**Submission to the Review of Environmental Impact Statement –**

**Santos Narrabri Gas Project**

**2017**

1:250,000 GEOLOGICAL SERIES SHEET SH 55-12

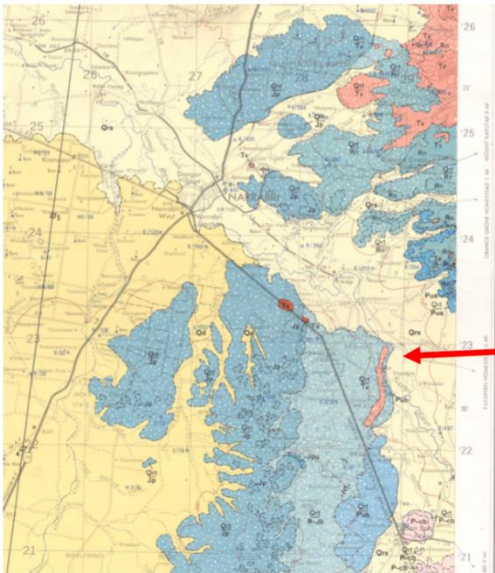
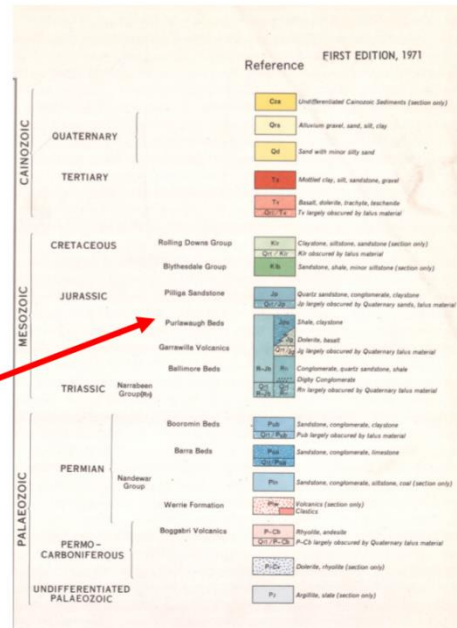
The map below clearly shows this statement to be incorrect.

The 1:250,000 geological map the Namoi Rv flows over the Purlawaugh Formation.

Namoi Rv  
Flows over the  
Jurassic Formations  
R-Jb

The Santos EIS does not consider the Purlawaugh Formation as part of the Great Artesian Basin. However, the Namoi Water Study on page 16 (pdf page 46) has: "GAB – GAB, Pilliga Sandstone and Purlawaugh Formation". Both of these formations are Jurassic in age, and the Pilliga Sandstone conformably overlies the Purlawaugh Formation - they are hydraulically connected.

REPORT DOCUMENT SS126 Report Identification number R00021480 Seismic survey final report.

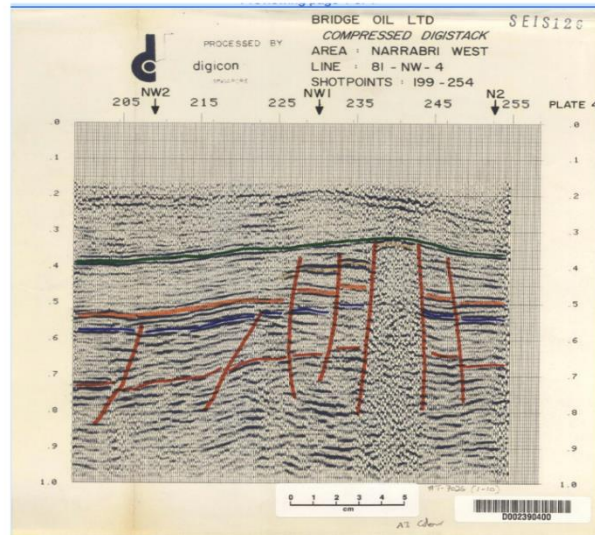
The Santos report states on page 11-25 that from the seismic data, no evidence has been found of large post Jurassic age faults that displace Permian age and Triassic age strata, with the amount of displacement being less than 100 m. The EIS concludes that where present surface faulting and displacement in the Jurassic age strata is found to be minor.

**Hydraulic connectivity between the coal seams and the GAB Pilliga Sandstone or Namoi alluvium could occur through gaps in confining layers, faulting or connection at the interface. Connectivity through the Jurassic and Permian units is most likely to be via fracture networks and faults the information that informs this assessment is critical. Namoi Water specifically asks that the**

**Department of Planning and DPI Water review the matter of connectivity through faulting in detail as part of the assessment process.**

A sample copy of part of the Narrabri Faulting Study is provided below showing faulting.
